## Review of the Environmental Impact Study for a New Facility for Co-Disposal of Tailings and Waste Rock at the Barrick Gold Pueblo Viejo Mine, Dominican Republic

Prepared for ENTRE (Espacio Nacional por la Transparencia en las Industrias Extractivas), submitted August 20, 2023

The Environmental Impact Study (EIS) for the new facility was finalized in October 2022 and released to the public on June 25, 2023. According to the EIS, the site and technology for the Naranjo facility was chosen after an initial screening of 26 alternatives followed by scoring of eight alternatives through a multiple accounts analysis that involved environmental, socioeconomic, technical and cost accounts. The purpose of this report is to determine whether the EIS selected the safest alternative and whether the preferred alternative provides adequate protection for people and the environment. To facilitate reading by non-specialists, this report includes a review of key topics in mine waste management, including the differences between tailings dams and water-retention dams, acid mine drainage, co-disposal of tailings and waste rock, the backfill of mine waste into exhausted open pits, and the Global I

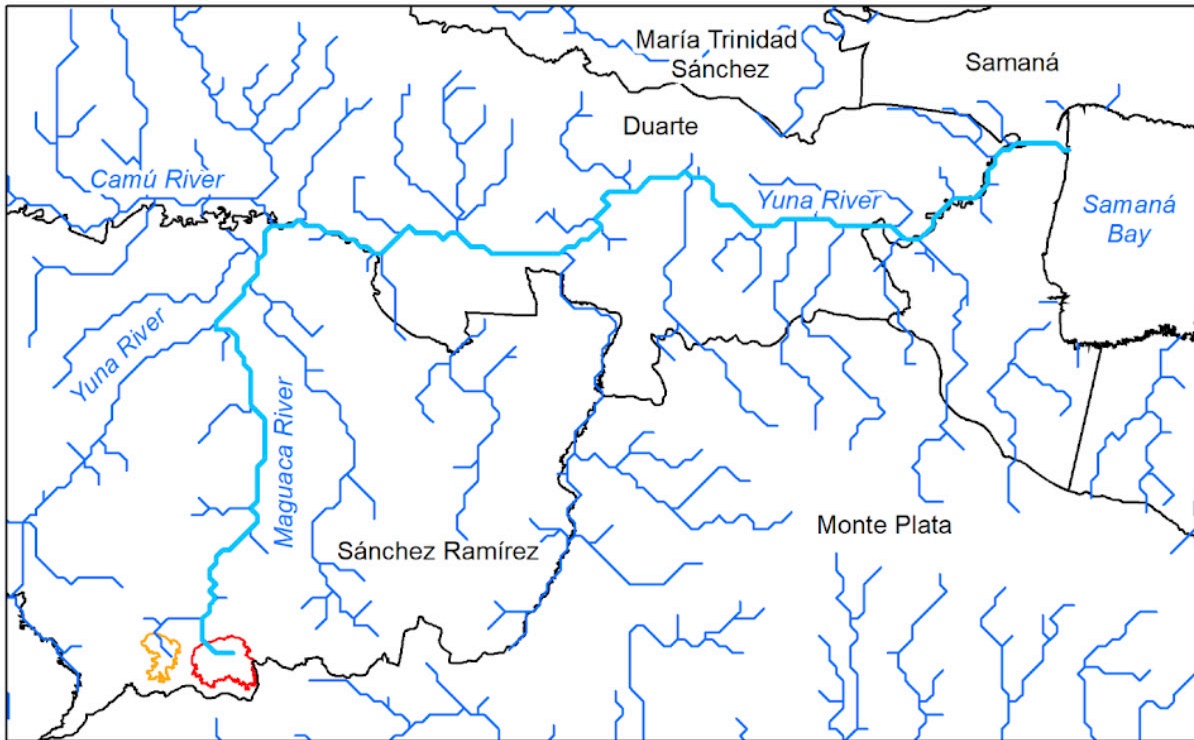
According to the analysis of the consequences of dam failure in the EIS, the spilled tailings will flow northward along the Maguaca River to the confluence with the Yuna River and then continue flowing northward along the Yuna River. The analysis calculates only the tailings flood arrival times, peak flow rates (up to 38,700 cubic meters per second), and the depths of the tailings flood (up to 22.4 meters), but not the environmental or socioeconomic consequences, such as fatalities, contamination of rivers, or impacts on human health, aquatic life, agriculture, or infrastructure. Moreover, the analysis is limited by the computer model, which calculated the tailings flood arrival times, peak flow rates, and depths only to the eastward turn of the Yuna River, a distance of 30 kilometers downstream from the Naranjo tailings facility. However, based on a statistical model developed from past tailings dam failures, with a height of 157 meters and storage of 278 million cubic meters of combined tailings, a failure of the proposed Naranjo tailings facility will result in transport of the tailings flood for 227 kilometers during the initial event. Since the distance to the ocean (Samaná Bay) is only 101 kilometers, the initial event will result in deposition of tailings along the entire reach between the tailings dam and the ocean, which will occur in less than five hours. Finally, although the El Llagal and Naranjo facilities would be only 840 meters apart and in the same watershed in the headwaters of the Maguaca River, the analysis of the consequences of dam failure did not consider the consequences of the simultaneous failure of both tailings storage facilities, although such an outcome is certainly credible considering that the same earthquake or precipitation event could cause the failure of both facilities.

The EIS systematically underestimates the consequences of tailings dam failure in two significant ways. The first is that there is no consideration of the consequences of the simultaneous failure of both the El Llagal and the Naranjo tailings dams. The EIS considered two possible scenarios for tailings dam failure, which were a “Flood-induced (Rainy-day)” scenario and a “Fair-weather (Sunny-day)” scenario. According to the EIS, “Flood-induced dam failures occur during large flood inflow conditions when the pond water level rises above normal operating levels. Given that the New TSF is planned to operate without an emergency spillway, an overtopping failure was considered a credible failure mode during a Probable Maximum Flood (PMF) event ... Fair-weather dam failures are assumed to occur when the pond is at its maximum annual operating level ... A release caused by a foundation failure triggered by an earthquake was assumed as the dominant credible failure mode. Given the proposed geotechnical design of the dam, this potential event has not been modelled as a sudden failure but a slumping of the dam to the New TSF pond surface elevation initiating a subsequent overtopping failure” (Knight-Piésold Consulting, 2022). In other words, it was assumed that tailings dam failure would initiate with either an extreme precipitation event or an earthquake. Given the proximity of the El Llagal and Naranjo facilities (see Fig. 3), it is certainly credible that the same extreme precipitation event or earthquake could cause the simultaneous failure of both tailings dams.

9. The industry-wide past experience with the design of the proposed facility should be analyzed.
10. The analysis of the consequences of dam failure should consider the simultaneous failure of both the existing and proposed facilities.

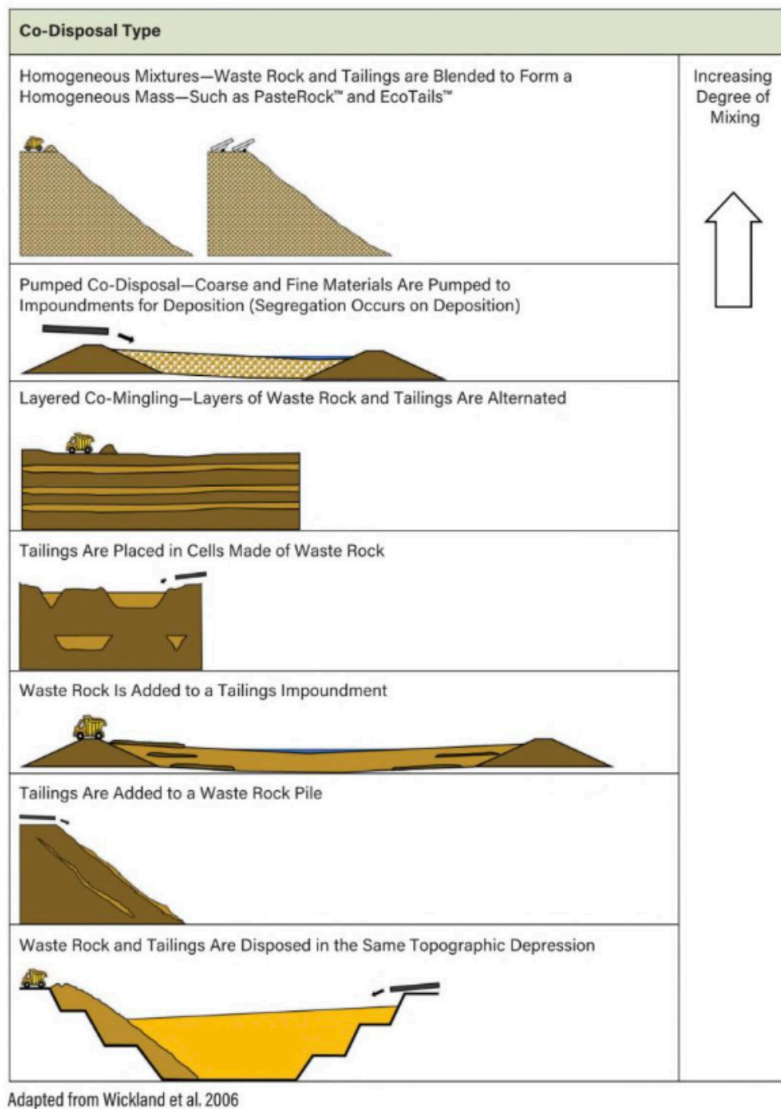
Fig. 6 shows a classification system for co-disposal of tailings and waste rock from the SME [Tailings Management Handbook](#) (Wickland, 2022). The various technologies for co-disposal are ranked in order from top to bottom from

the greatest to the least degree of mixing. The greatest mixing occurs when the waste rock and tailings are completely blended to form a homogenous mass, which should minimize the mine waste volume and maximize the protection against acid generation through contact with oxygen (see Fig. 6). Somewhat less mixing occurs when waste rock and tailings are pumped together to a storage facility. Some degree of segregation by particle size (thus, separating the waste rock and tailings) will occur at the point of deposition (see Fig. 6). Less mixing, but maintaining in some ways the additional shear strength from the waste rock, occurs when tailings and waste rock are deposited in alternating layers, or when tailings are deposited into cells constructed from waste rock (see Fig. 6). Even less mixing occurs when waste rock is added to a tailings storage facility or when tailings are added to a waste rock dump (see Fig. 6). The final category shows waste rock and tailings being added from opposite sides of a topographic depression (see bottom of Fig. 6). The topographic depression could be an exhausted open pit with the Kidston gold mine in Australia (Gowan et al., 2010) being an example. Whether any mixing occurs when two waste streams are discharged from opposite sides of a depression depends upon the mechanics of interaction of the waste streams. However, the discharge of two waste streams from opposite sides of a depression still retains the possibility of final, complete encapsulation of one type of mine waste by another. The real advantage of the deposition of potentially reactive mine waste into a topographic depression or exhausted open pit is that, if the waste is deposited below the water table, a water cover could permanently prevent contact with oxygen without a detrimental impact on physical stability, as would occur for an aboveground facility for storage of mine waste. This advantage is developed more fully in the next subsection.

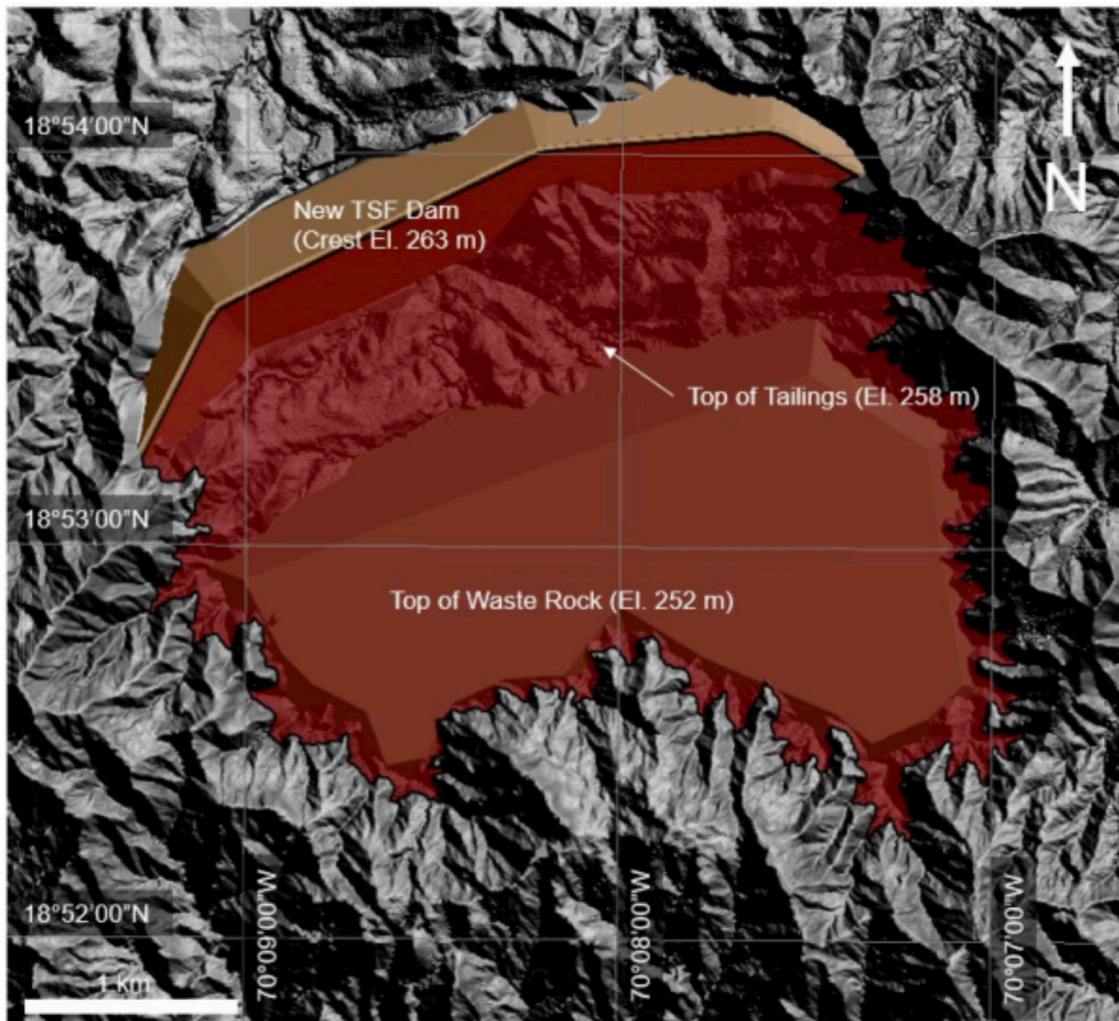
The co-disposal of tailings and waste rock into the same facility with a water cover on the waste rock and no mixing of the two types of mine waste is an unusual design. According to the EIS, the design is proven because the existing El Llagal facility has successfully used the same design. The EIS does not provide any evidence for the success of the El Llagal facility, such as annual dam safety inspection reports, dam safety reviews, or reports by an Independent Tailings Review Board (ITRB), although, according to the GISTM, such types of reports should be made available to the public, at least in summary form. The three-sentence summary in the public disclosure of August 5, 2023, cannot be regarded as adequate proof of success by any standard. However, although the 2005 EIS for the El Llagal tailings facility by Placer Dome stated that the facility would store both tailings and waste rock, the Technical Report by Barrick Gold to its investors clarifies that the waste rock has been stored in the Hondo waste dump, where it awaits transfer to either the open pit or the Naranjo facility, and lacks clarity as to how much, if any, waste rock is actually stored in the El Llagal facility. The El Llagal facility possibly uses a different design and is thus not analogous to the proposed Naranjo facility. To the knowledge of the author, the only mine waste storage facility with a similar design to the Naranjo facility is the tailings storage facility at the Phu Kham Copper Gold Operation in Laos. The avoidance of such a design on a worldwide basis is probably due to the very large dam needed to confine both the tailings and the waste rock, which could account for the high cost of the proposed Naranjo facility. Among other significant discrepancies between the EIS and the Technical Report, the EIS analyzes a much larger facility than is contemplated in the Technical Report, which is related to why only particular sites for the facility were considered in the EIS.
